OFFICIAL COORDINATION REQUEST FOR NON-ROUTINE OPERATIONS AND MAINTENANCE

COORDINATION TITLE- The Dalles Dam Diffuser Valve Maintenance Plan

COORDINATION DATE- 11 September 2018

PROJECT- The Dalles Dam

An additional larger diagram of the diffusers is attached.

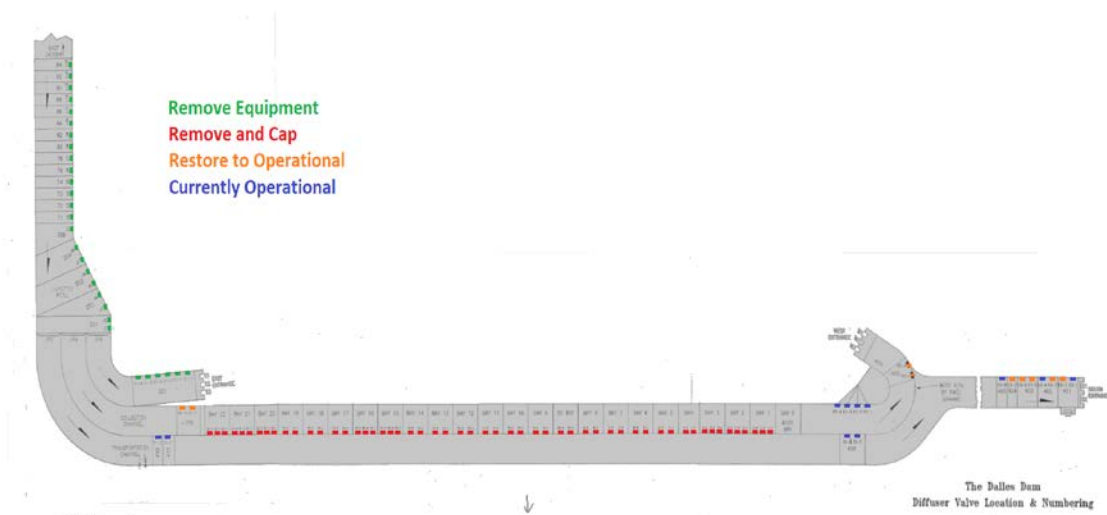
Many of the diffuser valves at The Dalles are no longer used due to semi-permanent closure of entry gates along the collection channel. They have been closed for many years and will remain closed. Project maintenance proposes to remove all operating mechanisms associated with these valves. In addition there are numerous diffuser valves in the junction pool, east entrance and lower east ladder that remain open and will not be closed under any foreseeable circumstance. Therefore it is proposed that these valve and mechanism be removed to eliminate unnecessary maintenance. The following chart shows valves and proposed plan. West entrance, south entrance and transportation channel diffuser valves will remain operational due to the potential closure needed in the event of using the AWS emergency backup system.

Could not find the original email with this attached. Couple of questions has someone at the COE run a hydraulic eval on this? If so could you share with us, maybe in the original MOC. I am a little quessy about getting rid of all of these devices. Along the collection channel is ok, the other areas not as certain. Would be could to have hydraulics check and make sure that we can cover the full range of pools op if all of these diffusers where removed.

Has the Portland district conducted a hydraulic analysis/evaluation of the AWS systems and fishways to determine what equipment is needed to make sure the ladder and entrances can stay within criteria under the full range of forebay and tailwater levels? I would like to see the results of this analysis before closing off anything. Off the top of my head, I don't think that I would agree to removing the equipment on all the North Fishway diffusers (1-A,-B,-C,-D,-E,-F,-G,-H,N-1,-2,-3,-4,-5,-6,-7,-8,-9) (highlighted in green in the diagram). Let me know if you have any questions.

No official hydraulic eval, but I did briefly run it by Schlenker. I vaguely recall even discussing it back in the Randy Lee days. With the AWS/fish unit test coming the end of Nov, we'll discuss the long term diffuser plan further. More to come.

We don't have an official hydraulic eval from district. Only conversations with hydraulic folks with no immediate objection to our plan. We'll do more consultation with district hydraulics on this issue, especially with the upcoming AWS testing.

For both east and north, we have not moved diffusers in many years. The only reason we ever moved them in the past was for isolating sections of the fishway for dewaterings in the late 90s. Otherwise we leave all but collection channel full open.

For the east, given the fact that AWS backup operation will not feed west and south, we chose to keep those functional.

For the north, we'll postpone that until we address all the east diffusers.

The whole idea is maintenance efforts on these valves is increasing with age. Many of the valves are stuck and require extensive labor to repair. Since they are never moved, we would like to spend funds and efforts on equipment we know is critical.
